Wellington South Battery Energy Storage System

Submissions Report

Prepared for AMPYR Australia Pty Ltd

J210534 RP1

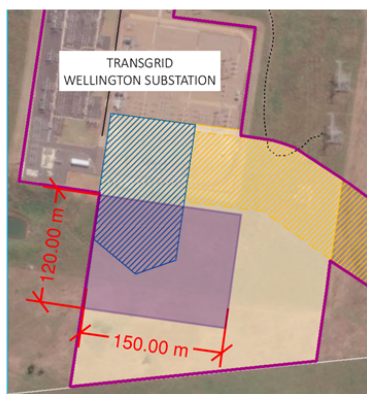
Yes – Transgrid would require minimum 120m x 150m area on the southern side of the Wellington Substation, as indicated below:

I note that the location of this 120 x 150 is flexible, if we need to move it slightly to avoid impacting habitats, that shouldn't be an issue.
